RE: Lot 1, Block 3, Wasilla Heights #1 (Convenience Store, Apartment
and Office Building) On-site Wastewater Disposal System

RE: Lot 1, Block 3 Wasilla Heights #1, (Convenience Store, Apartment & Office Bldg.)
Class C Public Water System and On-site Wastewater Disposal System

ENGINEER REPORT

PROPOSED SITE DEVELOPMENT PLAN
 LOT 1, BLOCK 3, WASILLA HEIGHTS #1
 DENNIS ILLIES CONVENIENCE STORE AND GAS STATION
 PROJECT NO: 184053 SCALE: 1"=50' DATE: 2/27/84
 DRAWN BY: CL DESIGNED BY: KV SHEET 1 OF 1

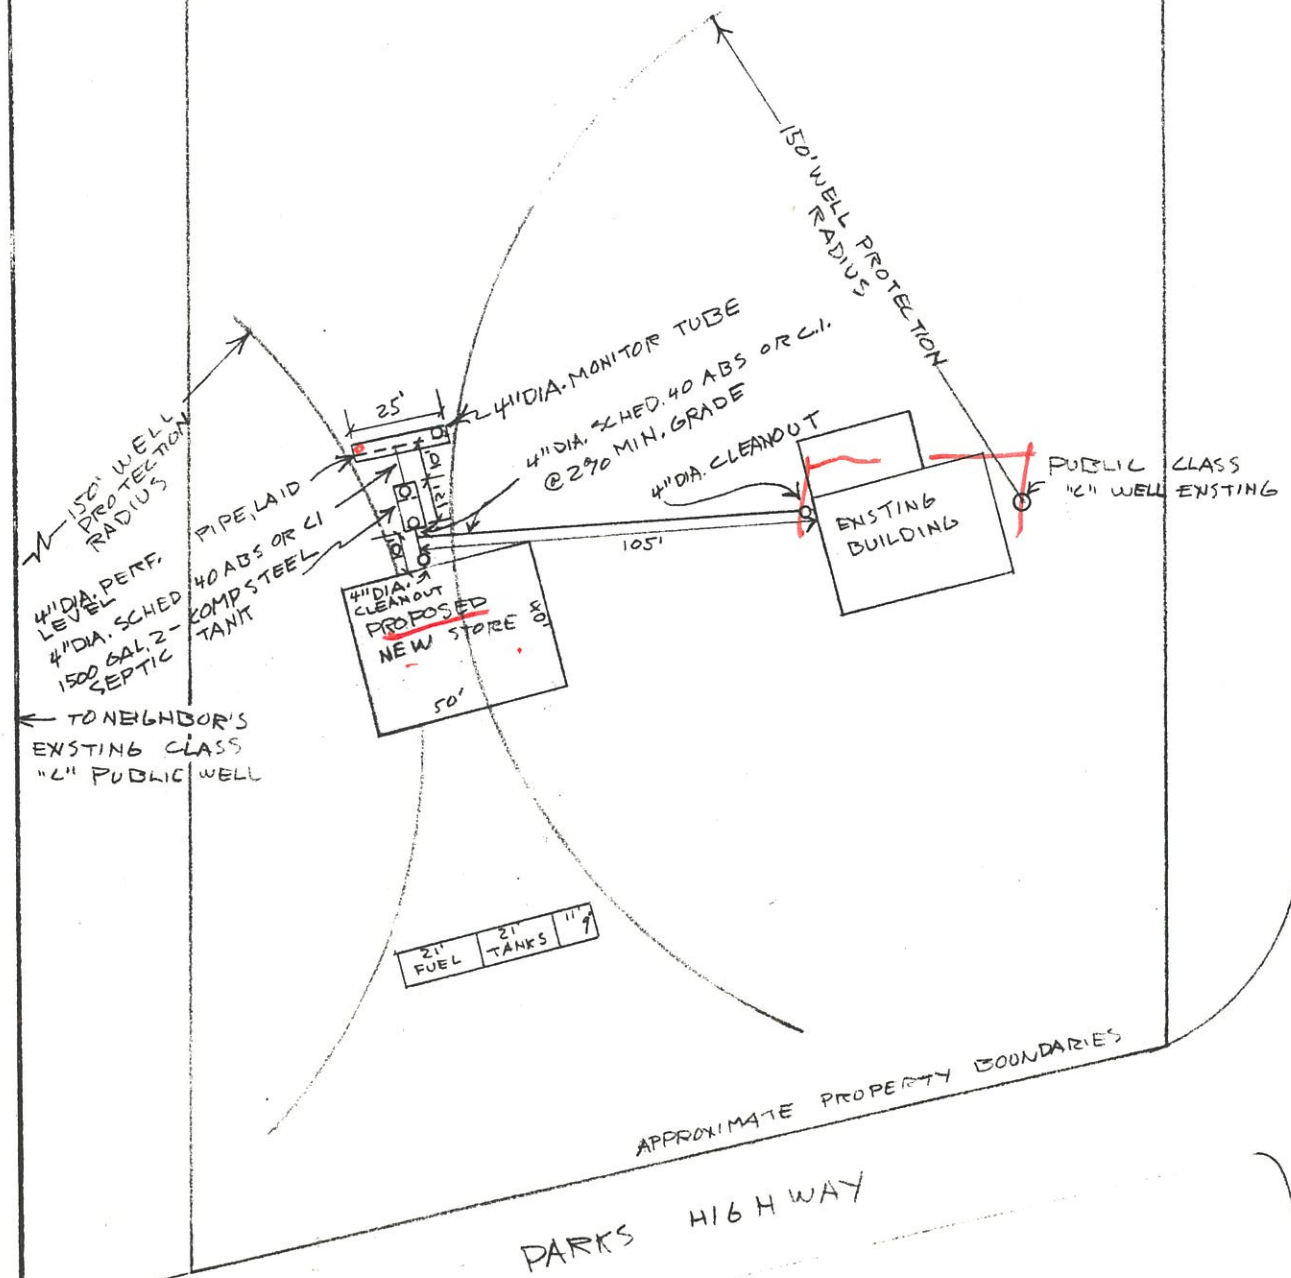
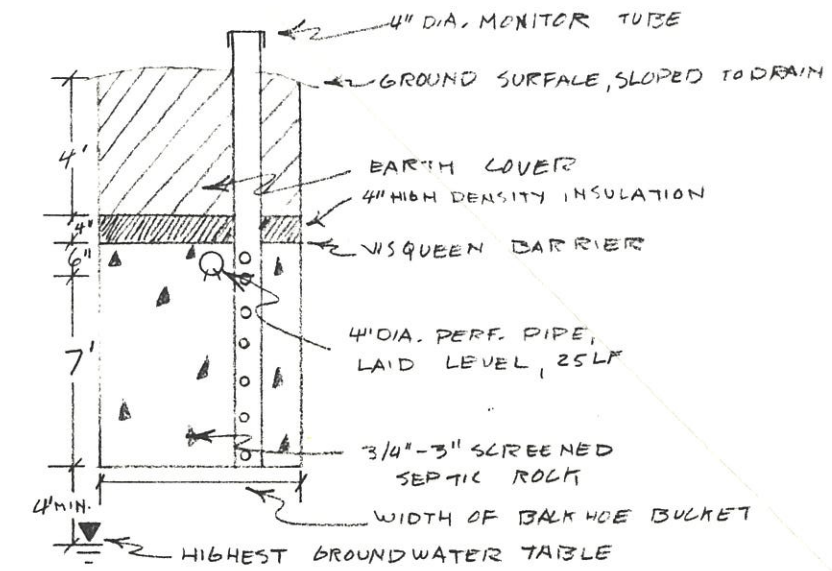
As noted on the plans the convenience store, apartment, and office building will be served by a well, which, as proposed, would be a Class C Public Water System source. This well requires a minimum 150 foot separation from any wastewater disposal system, and 75 feet separation from private sewerlines. Based on the location of the well, as shown by the plan, these requirements will be met. It is emphasized that careful control of the specific siting must be maintained to insure that these minimum separation distances are obtained. Subject to these comments, the plans are approved in accordance with provisions of 18 AAC 80, Drinking Water. A Construction Certificate, constituting this approval, is enclosed. Prior to providing any drinking water to the public (residents), the operation portion of this certificate must also be issued by this Department. This will require submittal of satisfactory test results for total coliform bacteria on a sample from the well and a copy of the well log. Pump sizing and storage requirements must also be determined and submitted to this office for review and approval prior to the installation of these system components.

Based on the intended use of the facility (460 gpd estimated flow), and your assumption of subsurface soil conditions, as detailed in the submitted data, my review reveals that the wastewater disposal system for the facility is adequately sized (1500 gallon, 2 compartment septic tank and a ³⁵⁰ ~~250~~ ft. ² soil absorption system) as noted on your plans.

Therefore, subject to a requirement for a preburial inspection by a Professional Engineer, including verification of soil conditions watertable separation, and subject to submittal of unqualified "as-builts" under your stamp as a Professional Engineer, these plans are approved for concerns of this Department, in accordance with provisions of 18 AAC 72, Wastewater Disposal.
